Access Compliance Report

Public Rights-of-Way

Intersection ID: 6957	Main Street: N_TRYON_ST	Cross Street: N_US_29_BY-PASS_HY	Location:	E
ADA ID: EAA16E728787	Ramp Type: Perp	Initial Pass/Fail: Pass	Overall Compliance: No	Severity Score: 20

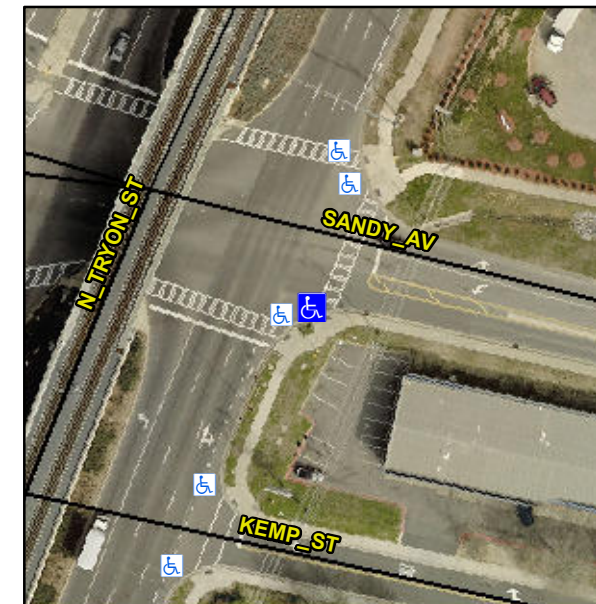
**Not Found, R302.7, R302.7.2,
R304.5.4**

Compliance	Description	Data	Compliance	Description	Data
N/A	Ramp Length (in)	72.0	Yes	Ramp Slope (%)	7.2
Yes	Ramp Width (in)	48.0	Yes	Ramp XSlope (%)	0.9
N/A	Flare Type LT	Sloped	N/A	Flare Type RT	N/A
N/A	Flare Slope LT (%)	6.5	N/A	Flare Slope RT (%)	7.4
N/A	Flare Traversable LT?	Yes	N/A	Flare Traversable RT?	No
Yes	Landing Length (in)	52.0	Yes	DWS Provided?	Yes
Yes	Landing Width (in)	48.0	Yes	DWS Contrast?	Yes
Yes	Landing Slope (%)	1.9	Yes	DWS Length (in)	24.0
Yes	Landing X Slope (%)	1.0	Yes	DWS Full Width?	Yes
N/A	Landing Curb? (Y/N)	No	Yes	DWS Offset (in)	1.0
N/A	Shared Landing?	No			
No	Gutter Ponding?	Yes	No	Gutter Slope (%)	6.8
No	Gutter Lip Ht (in)	1.0	Yes	Gutter X Slope (%)	0.5
N/A	Painted X Walk1?	Yes	N/A	Painted X Walk2?	N/A
	X Walk 1 Direction	To NE		X Walk 2 Direction	N/A
N/A	X Walk 1 Width (in)	110.0	N/A	X Walk 2 Width (in)	N/A
	X Walk 1 Slope (%)	0.4		X Walk 2 Slope (%)	N/A
	X Walk 1 X Slope (%)	2.6		X Walk 2 X Slope (%)	N/A

Possible Solutions:

**Remove & Replace Entire Ramp.
Remove & Replace Gutter.**
